U S NAVY RESPONSE TO SOUTH CAROLINA DEPARTMENT OF HEALTH AND  
ENVIRONMENTAL CONTROL COMMENTS RCRA FACILITY INVESTIGATION ADDENDUM  
AND CORRECTIVE MEASURES STUDY WORK PLAN AREA OF CONCERN 596 (AOC 596)  
ZONE E CNC CHARLESTON SC  
3/13/2003  
CH2M HILL

AOC 596 Zone E  
RFE Report Addendum + CWB Workplan

**Re:** CH2M-Jones' Responses to Comments by SCDHEC regarding the *RFI Report Addendum and CMS Work Plan, AOC 596, Zone E, Revision 0*

**Figure 2-1**  
RFI Sampling Locations  
AOC 596, Zone E  
Charleston Naval Complex

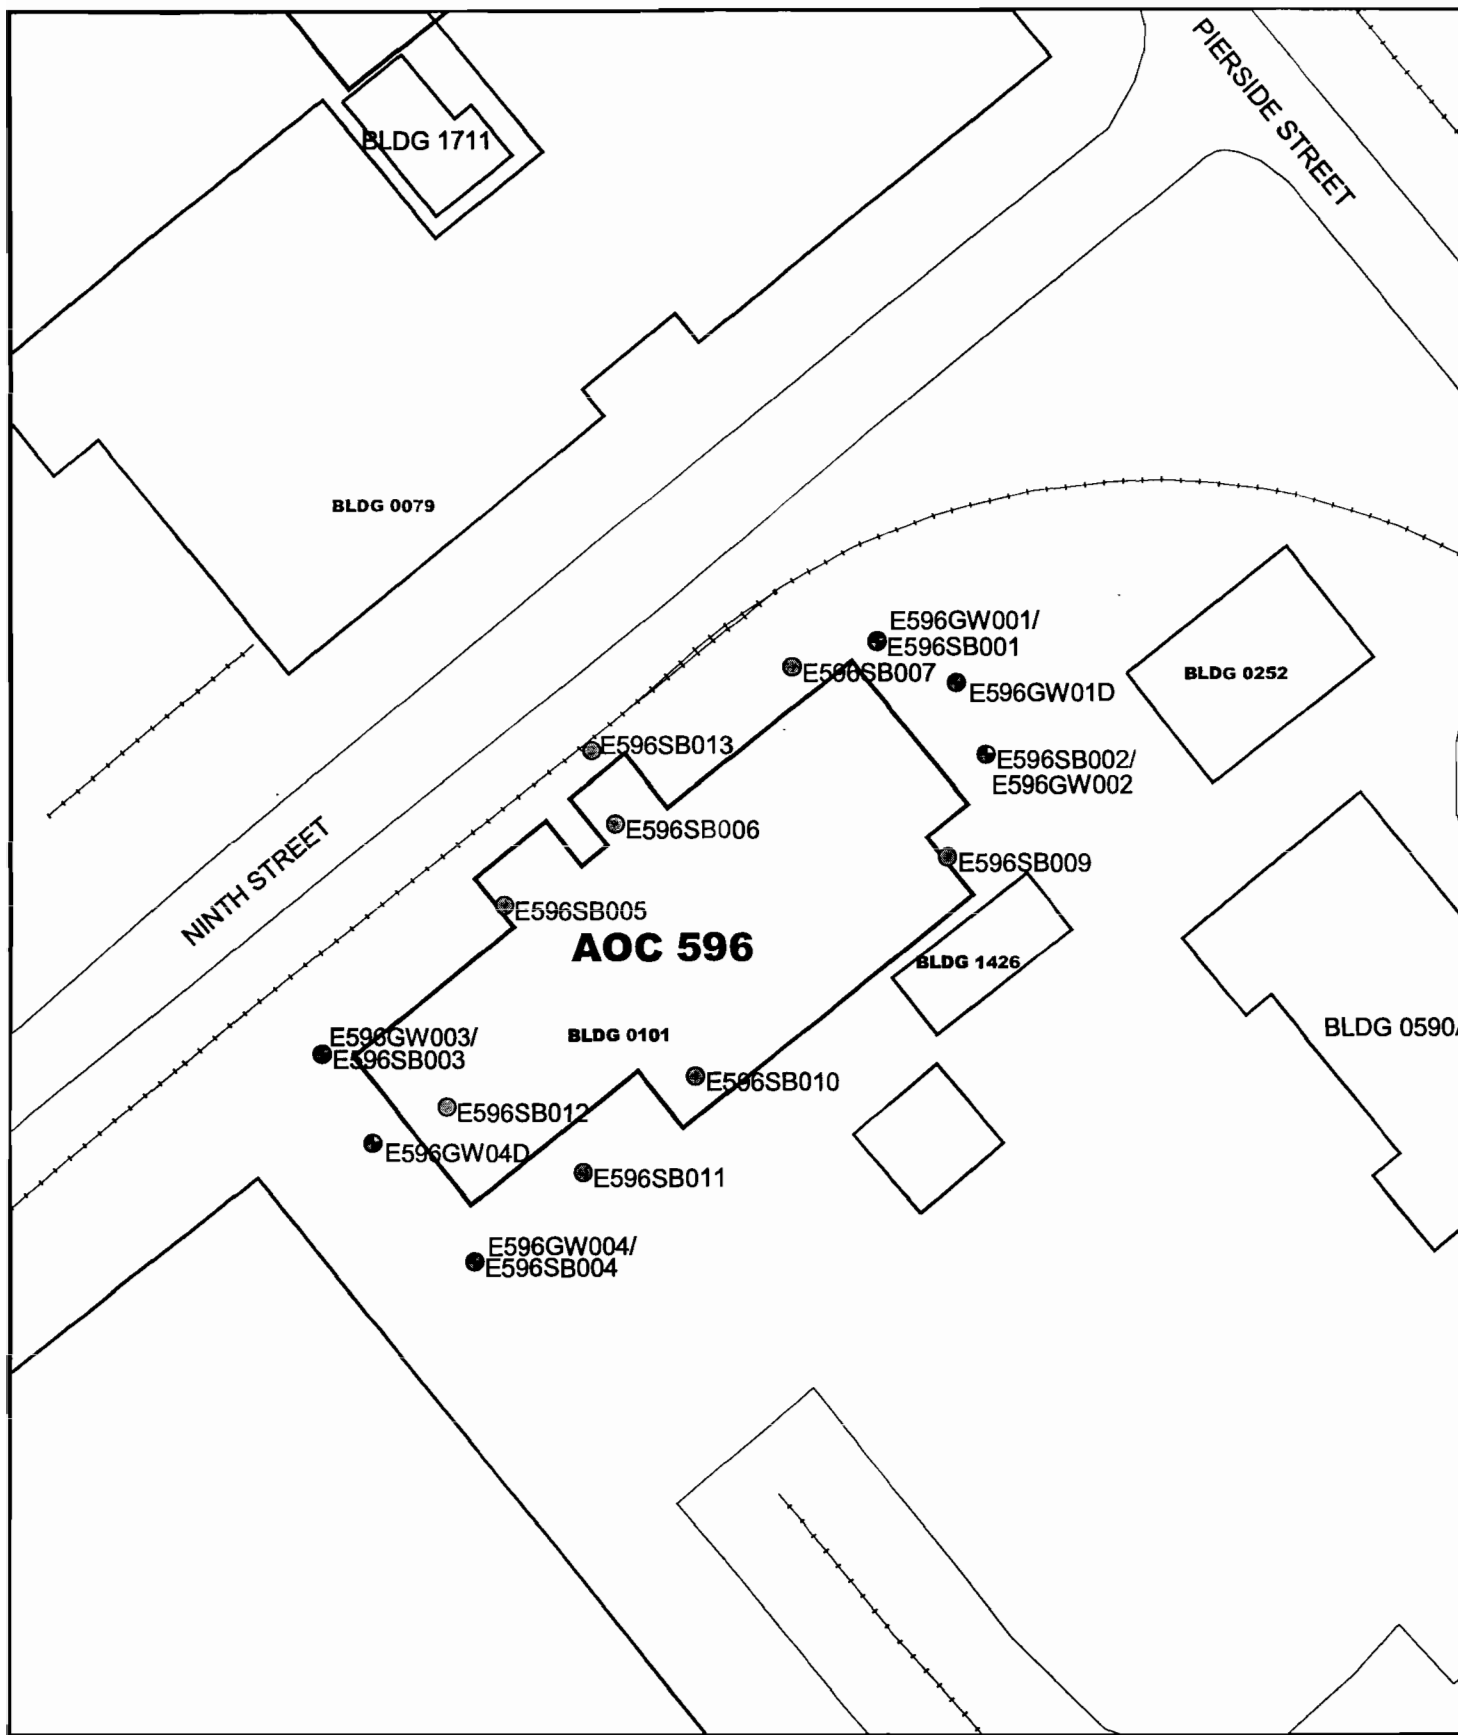
1. Figure 2-1 does not indicate the soil sampling location of:
  - a. E596SB005
  - b. E596SB008

2. Figure 4-1 does not indicate the soil sampling location of: E596SB008

3. Additional soil sampling is required to delineate the BEQ contamination area associated with soil sample E596SB006 even though soil sample E596SB014 indicated "no detections of carcinogenic polycyclic aromatic hydrocarbons (PAHs)(i.e. BEQ) above laboratory detection limits in the surface soil sample." Given the very high detection of BEQs in the surface soil, E596SB006 should be bracketed to ensure that the BEQ contamination is fully delineated.

*The Zone E RFI Report, Revision 0 (EnSafe, 1997) indicates in Section 10.45.1 that the soil boring at E569SB008 could not be advanced due to the thickness of the cement floor being greater than 3 feet. Therefore, no sample was taken at E596SB008. Figure 2-1 inadvertently omitted the location of E596SB005. A copy of the revised Figure 2-1 is attached and will be included in the Revision 1 of the RFI Report Addendum/CMS Work Plan (RFIRA/CMSWP).*

*Please response to Comment 1.*

*Boring E596SB006 is already "bracketed" by borings E596SB005, E596SB007, and E596SB013 (see attached Figure 2-1). None of these three soil borings had BEQs greater than the sitewide reference concentration.*
